### Submissions on an environmental impact statement (EIS)

Name of Project: Lake Vermont Meadowbrook Project  
 Submitter: Department of Environment and Science

1 June 2023

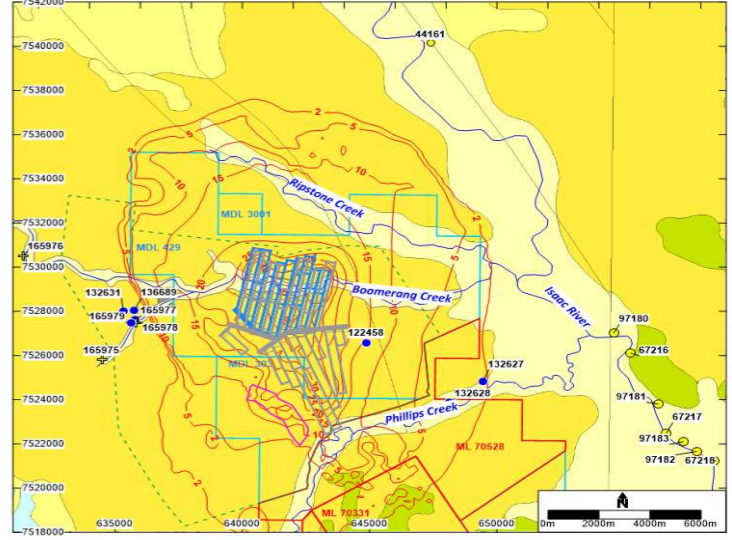
18	Chapter 20: Transport	<p><b>Traffic volumes</b></p> <p>The project identifies some background traffic however it has not considered the entire list of roads as identified in the comments included as part of the "Surrounding Road Network Details" feedback.</p> <p>It is also noted that the assessment fails to identify the percentage of traffic between Dysart and Lake Vermont Mine Access that is project related traffic</p> <p>The report does not confirm the percentage of project traffic impacting the section of Golden Mile Road between lake Vermont Access and Fitzroy Developmental.</p>
